RE: Jomar/Martinez Residence 2123 Candelaria NW – Lot 2

Request for Pad Certification – Accepted

Grading Plan Stamp Date: 8/23/18

Certification Dated: 1/4/19 Drainage File: G13D035

2123 CANDELARIA RD **ENGINEER'S** SEAL JOMAR CANDELARIA RESIDENCE GRADING AND DRAINAGE PLAN 8/23/18 8/1/18 DAVID SOULE

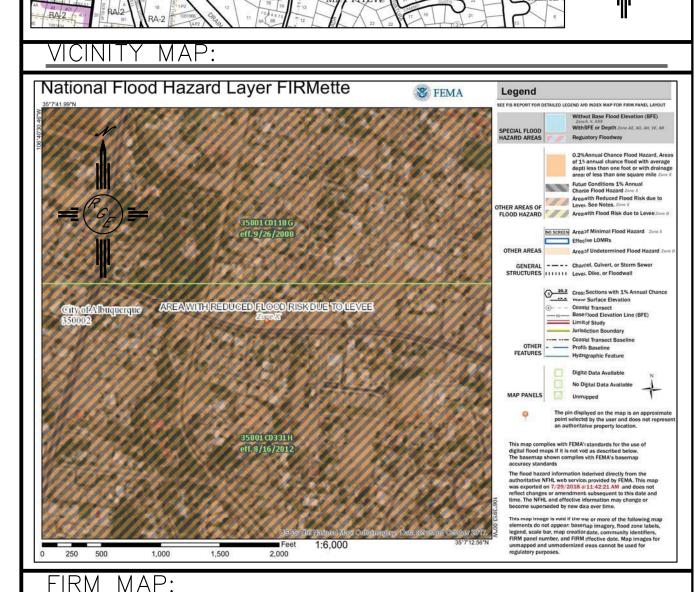
Based on the submittal received on 1/4/18, the Engineer's Certification is approved for Building Permit for Lot 2.

- 1. Engineer's Certification, per the DPM Chapter 22.7: *Engineer's Certification Checklist For Non-Subdivision* is required to ensure the site, ponds, and the grades along the property lines were not disturbed during home construction.
- 2. The site must be surveyed and pond volumes certified.
